RE: TEDS Exception No. 31-03, for Access Offset Spacing at 779 22 Road

**DESIGN EXCEPTION #DE31-03**

**Re: SPR-2003-075: 84 Lumber Yard Expansion  
TEDS Exception Request**

SITE PLAN

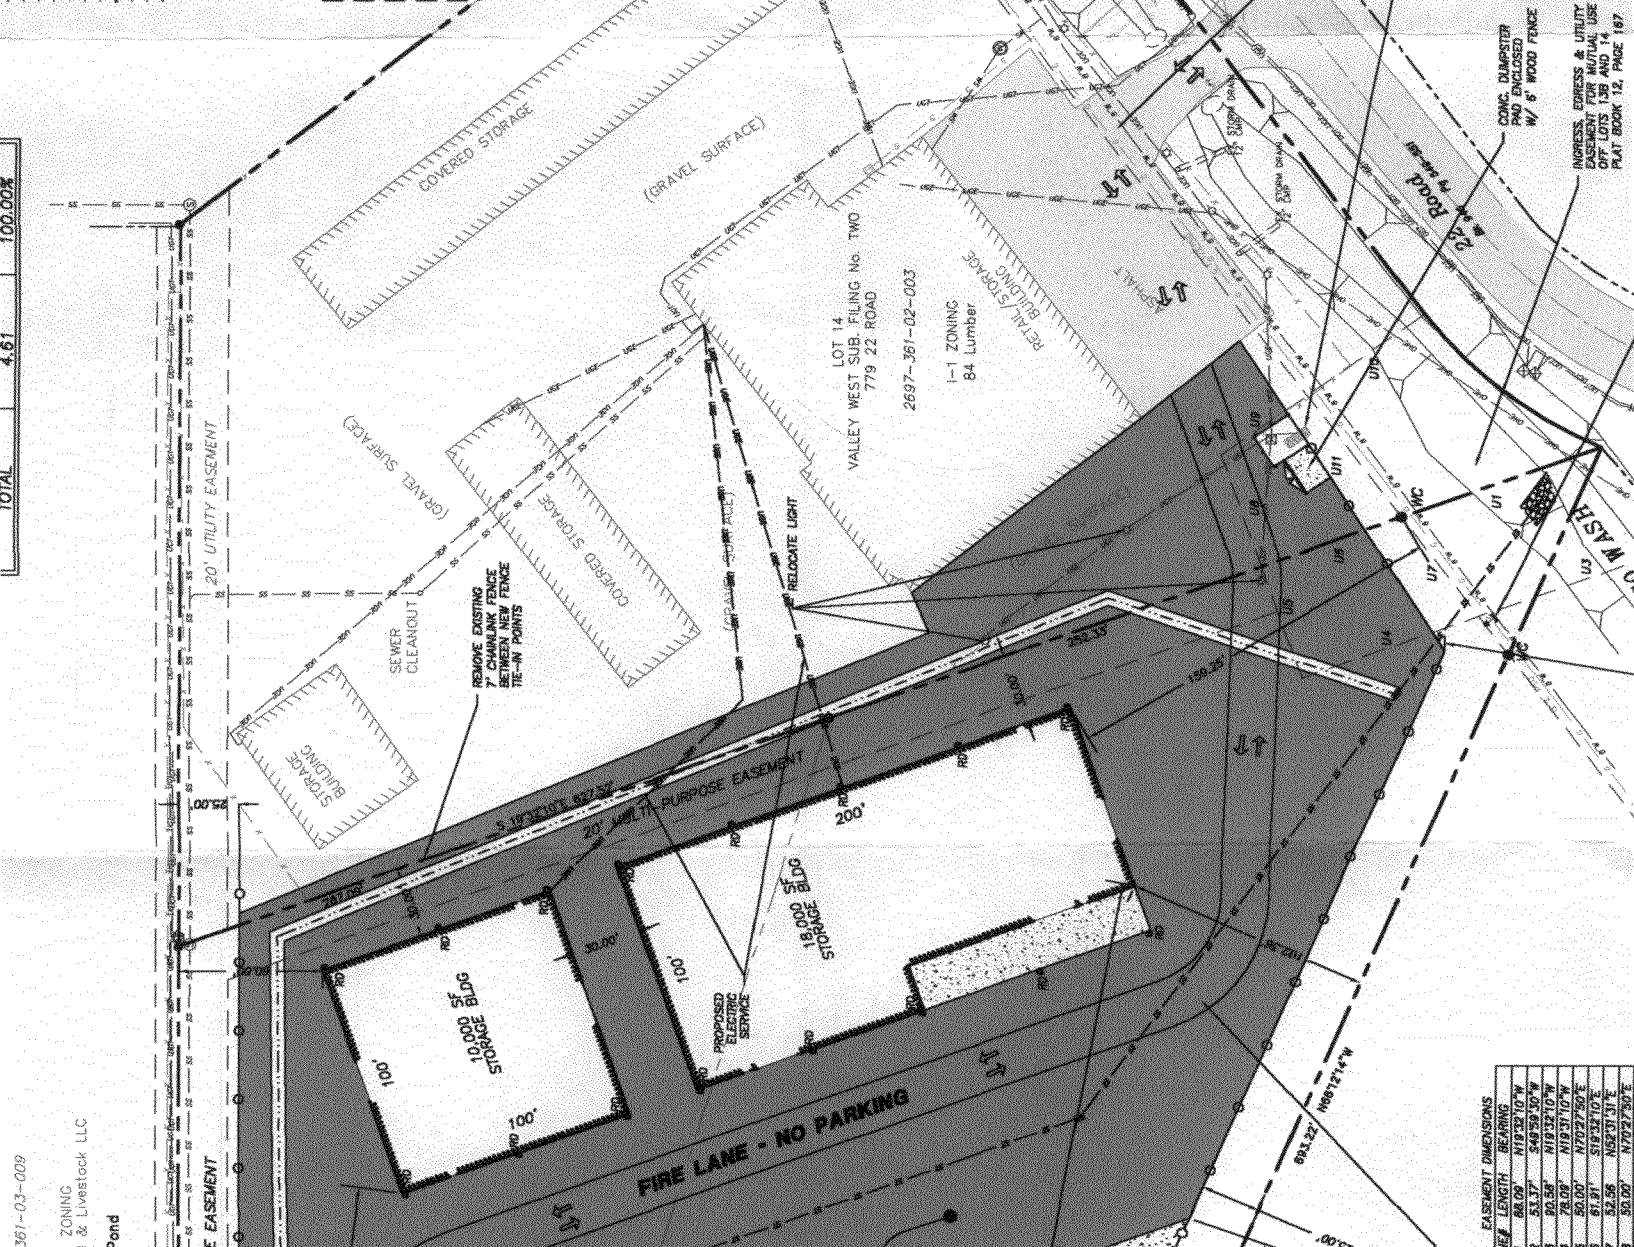
Applicant is planning to construct 28,000 SF of additional storage on a lot adjoining the existing facility. This expansion justifies a review of all of the improvements on both lots. The existing access to the original 84 Lumber store is offset a distance of 35 feet from another gravel driveway into a single family residence across 22 Road. The existing driveway into 84 Lumber crosses Persigo Wash via a large rusty multi-plate metal culvert, which appears to be approaching the end of its service life. The existing access to 84 Lumber is as narrow as eighteen feet. TEDS will require that it be widened to at least twenty-eight feet. This work may, or may not also require the replacement of the culvert carrying Persigo Wash. Section 4.1.2, *Offsets*, requires that access either be opposite each other or be separated by at least 150 feet.

The applicant requests exception from Section 4.1.1, *Spacing*. However, the correct request would be for an exception to Section 4.1.2, *Offsets* since this relates to spacing between the applicant's driveway and another on the opposite side of 22 Road.

Volumes are relatively low on 22 Road although this and other developments in the area will tend to increase these numbers over time. Trips into 84 Lumber will increase "as 84 Lumber continues to provide inventory that meets the needs of the Grand Valley." Although this is not a major high risk situation, it would be safer with opposing accesses.

The applicant has also considered relocating the residential driveway across the street, but believes this is "not appropriate because the opposing access serves a non-conforming use." The problem is that this non-conforming use has every right to remain there as long as it wishes. I do not agree that this plan can depend on the eminent re-development of that property. I believe that this is a real option that the applicant needs to pursue.

There may also be another option available coincidental to whatever their plan might be to expand the current access to meet the 28-foot minimum requirement.

I recommend denial of the requested Design Exceptions to Section 4.1.2, *Offsets*. It appears to me that there are options available that would lead to conformance to TEDS.

If the required widening of the driveway also requires the replacement of the Persigo Wash culvert, I would agree the driveway should be relocated to conform to TEDS. If, however, the existing culvert can accommodate the widening, and future redevelopment of the site across the street could result in that access point being modified, I recommend the exception be granted for 84 Lumber. The offset access point serving the non-conforming single-family home has such low traffic volumes, it is unlikely to create a significant safety issue.
